Transport, Heritage and Planning Committee

Fire Safety Reports

File No: S105001.002

Fire Safety Report Summary Sheet

Figure 1

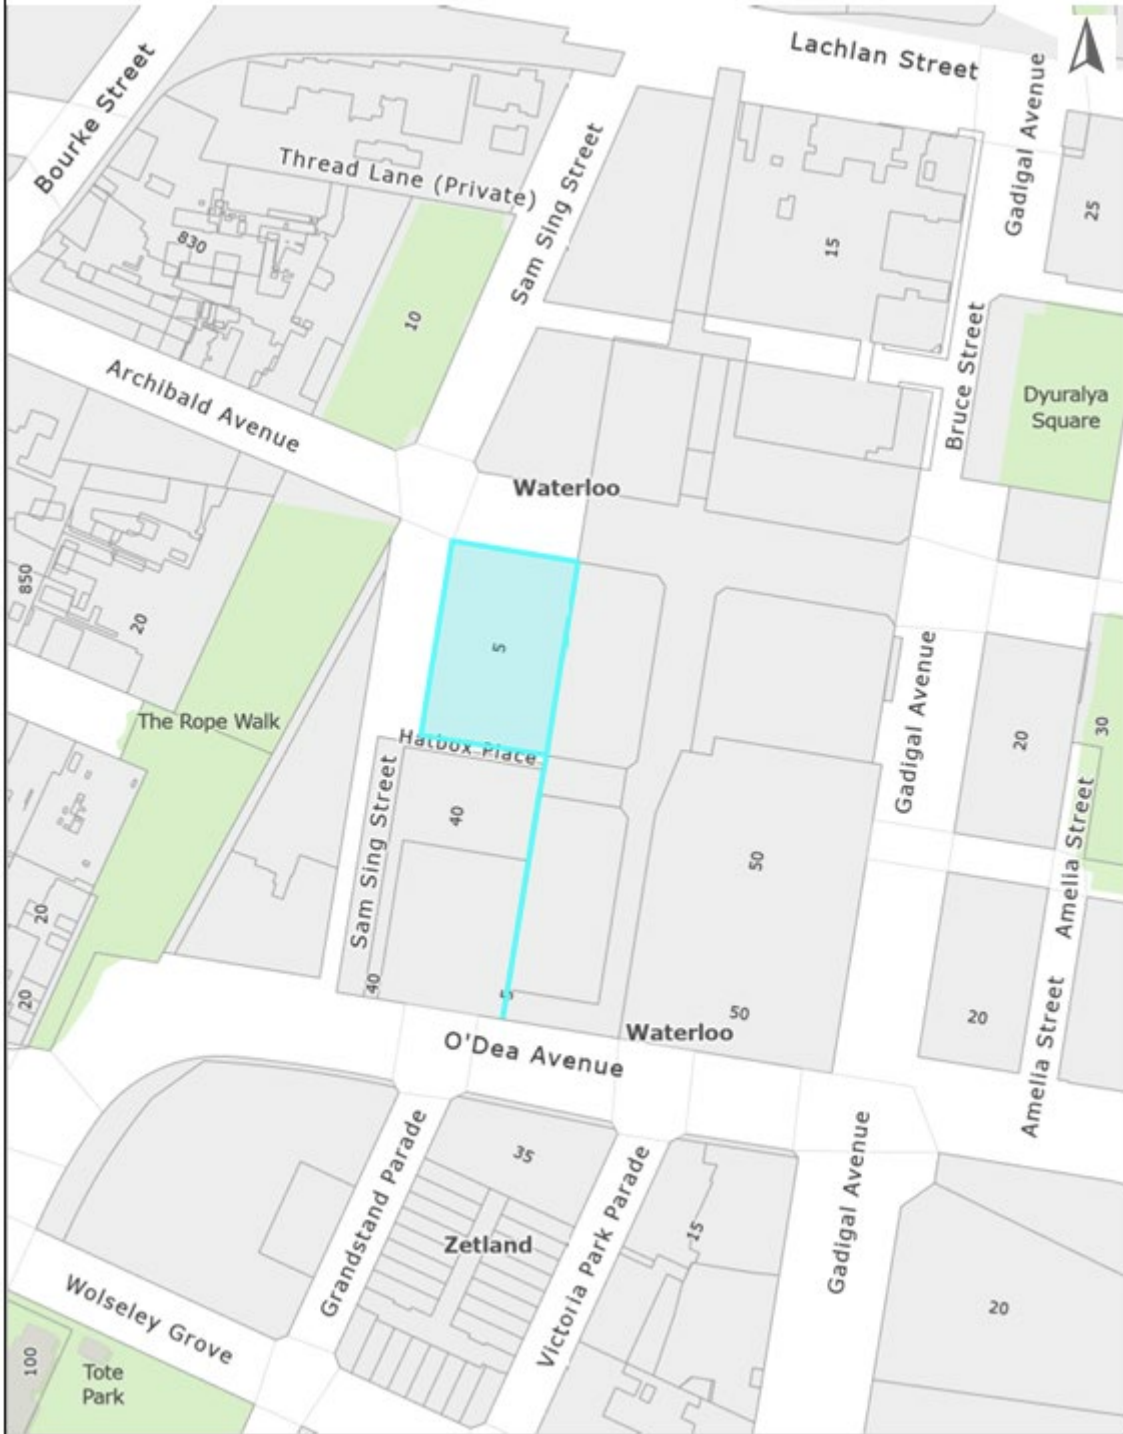
FRNSW position statement [FRNSW pump performance for high rise buildings](#) states, the fire hydrant system is to be designed for a 'Boost Pressure' of 950 kPa being input into the fire brigade booster connection from a standard FRNSW pumper, for buildings having an effective height greater than 50 m and requiring a fire brigade relay pump. FRNSW are of the opinion that the boost pressure signage should state, BOOST PRESSURE 950kPa and the relay pump be modified to ensure correct operational pressures.

Additional signage should be installed at the 150mm pressure gauge similar to *Figure 1*, to advise firefighters of the required pressure at the RELAY PUMP discharge.
